ADDENDUM NO. 02
February 15, 2022

To Drawings and Specifications dated February 2, 2022.

FRIENDSWOOD HIGH SCHOOL ADDITIONS & RENOVATIONS
FOR FRIENDSWOOD I.S.D.

Prepared by: PBK
11 Greenway Plaza, 22nd Floor
Houston, TX 77046-1104
PBK Project No: 20381

01 PLAN–PLANTER DRAINAGE
1"=20'-0"

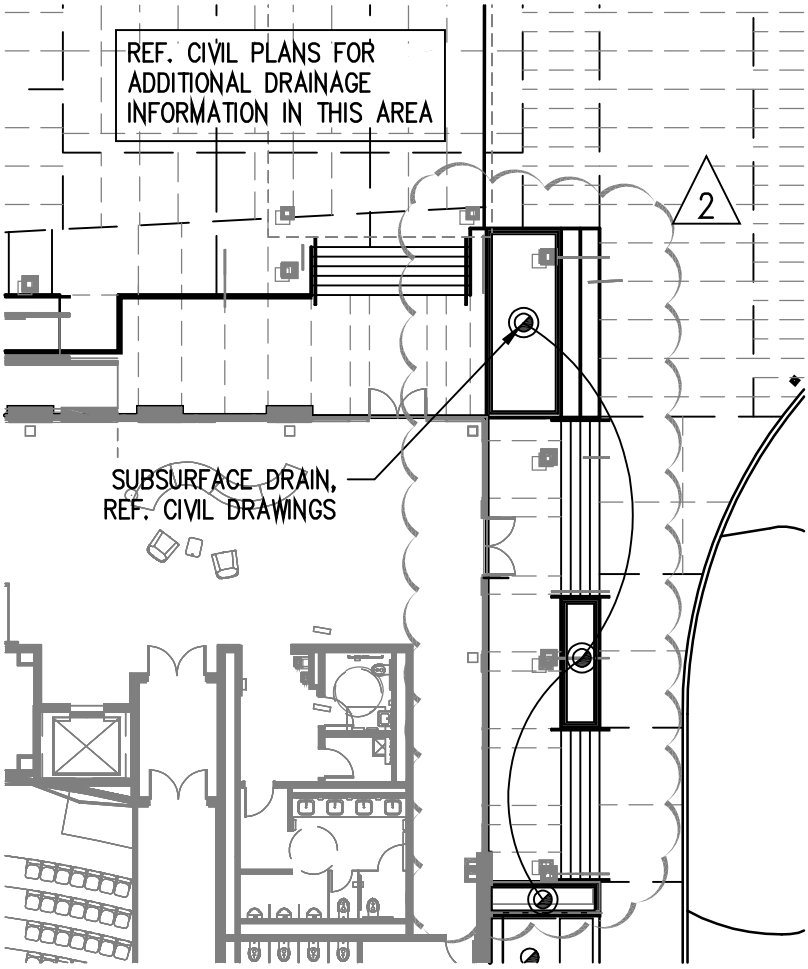
Item No. 27 **Sheet L1.04:** Drainage system to be installed with cast-in-place concrete planters at PAC entry/stairs. Reference SKL-001.
Item No. 28 **Sheet L2.00:** Replace sheet in its entirety.

01 SECTION-PLANTER
NOT TO SCALE

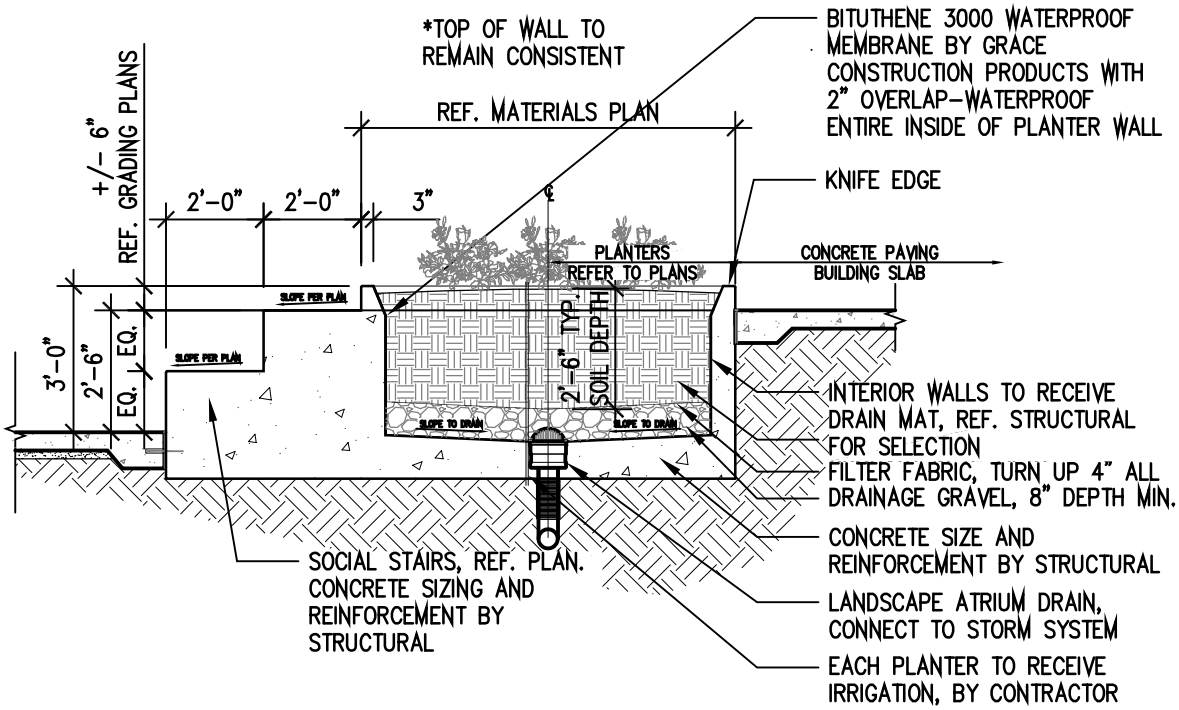
Item No. 29 **Sheet L3.02:** Detail shows to include drainage mat, non-woven filter fabric, drainage gravel, and sub-surface atrium drain. Reference SKL-002.
